City of Detroit  
Inter-Departmental Communication

**RE:** Petition No. 151  
Requested Encroachment Into Newport at 5503, 5511 And 5517 Newport. (With  
Concrete Curb Inlet, Trench Drain Cobble Spillway, Concrete Curbs and  
Concrete Sidewalks)

## **PROVISIONS FOR ENCROACHMENT For Petition 151**

REQUEST ENCROACHMENT  
 INTO NEWPORT  
 5503, 5511 AND 5517 NEWPORT AVE.  
 (With Concrete Curb Inlet, Trench Drain  
 Cobble Spillway, Concrete Curbs  
 and Concrete Sidewalks)

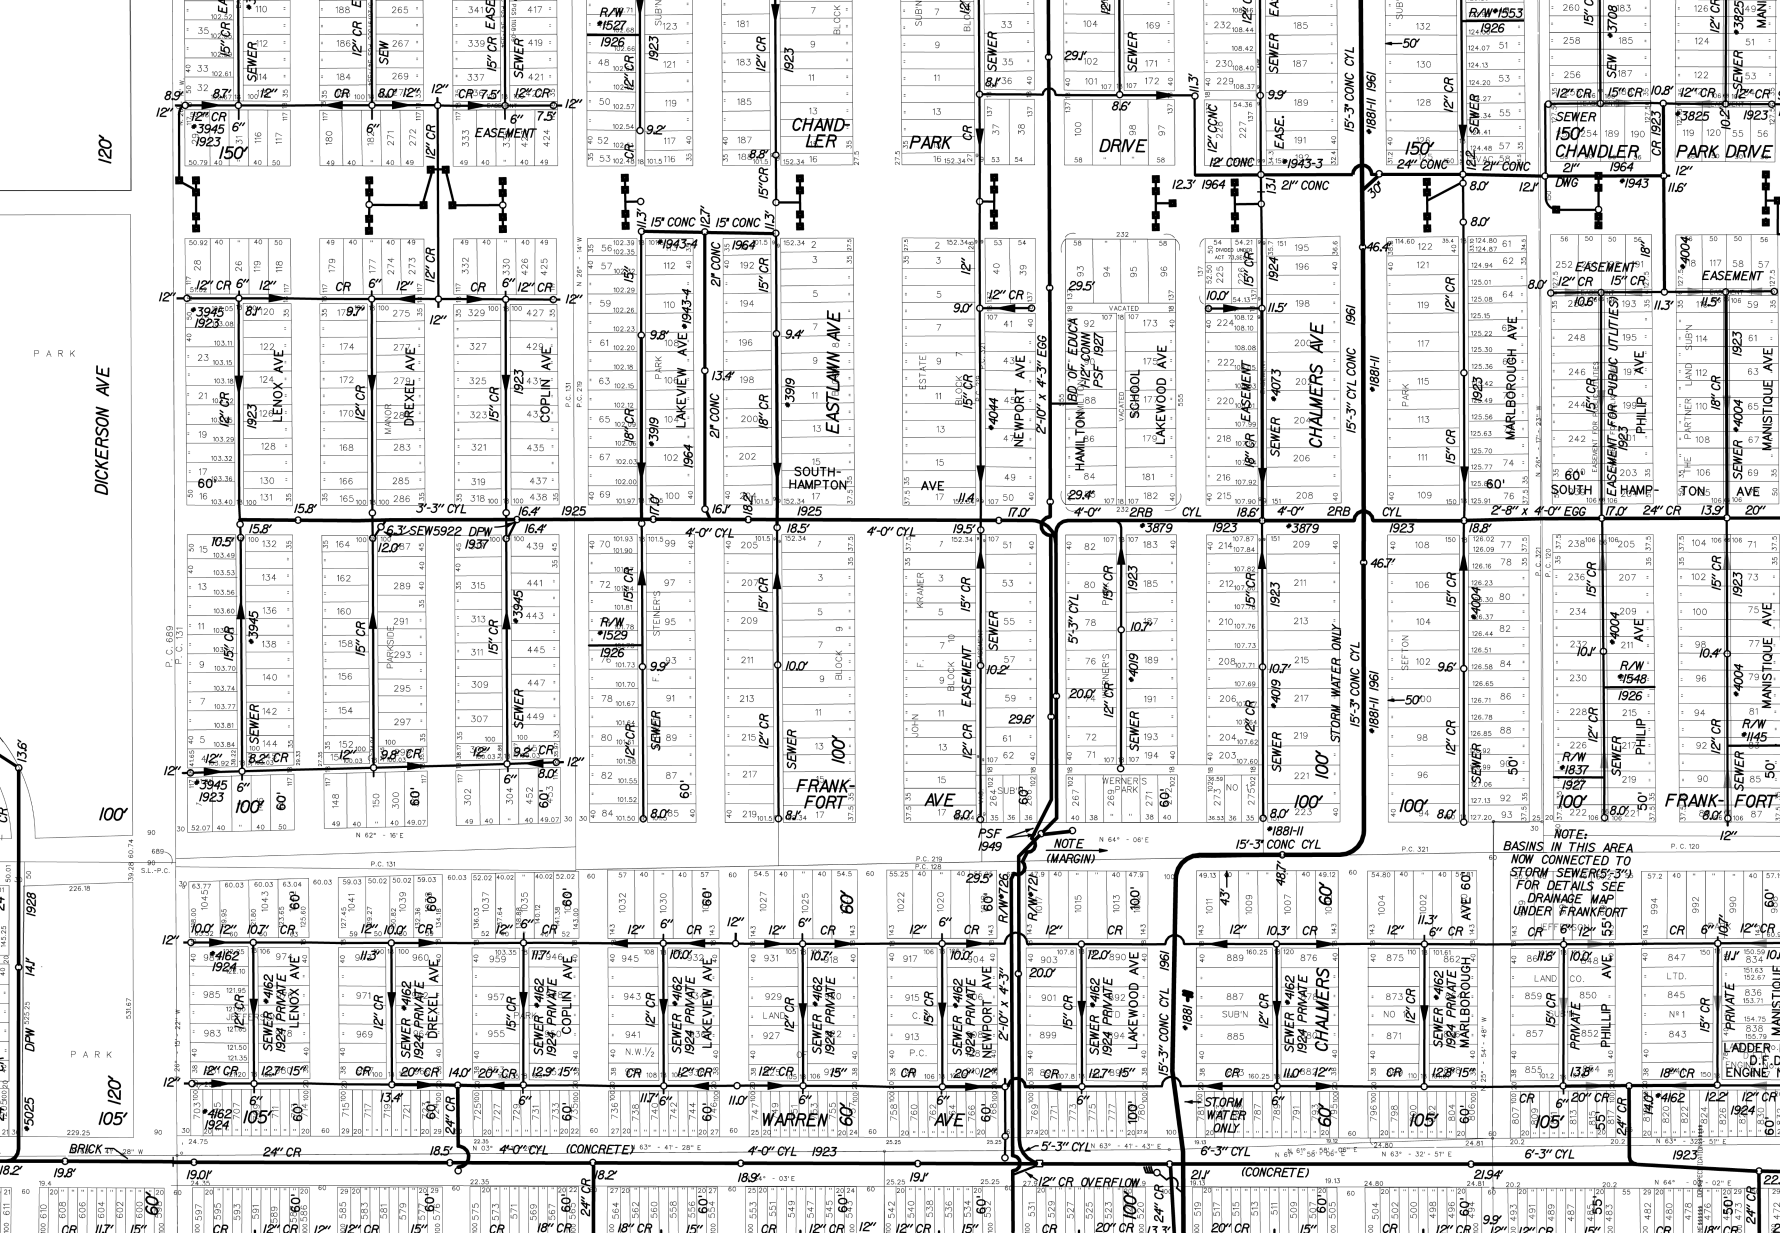
We have reviewed the above Petition received by this office. Our records indicate there are water mains and sewers in the area of encroachment. With regard to DWSD's interests, our comments are as follows:

- DWSD has no objections to the requested encroachment provided that the attached Provisions for Encroachment are strictly followed.

2. DWSD requires a vertical clearance of 18 feet above grade for maintenance excess and repair.
3. All construction performed under this petition shall not be commenced until after five (5) days written notice to DWSD. Seventy-two (72) hours notice shall also be provided in accordance with P.A. 53 1974, as amended, utilizing the MISS DIG one call system.
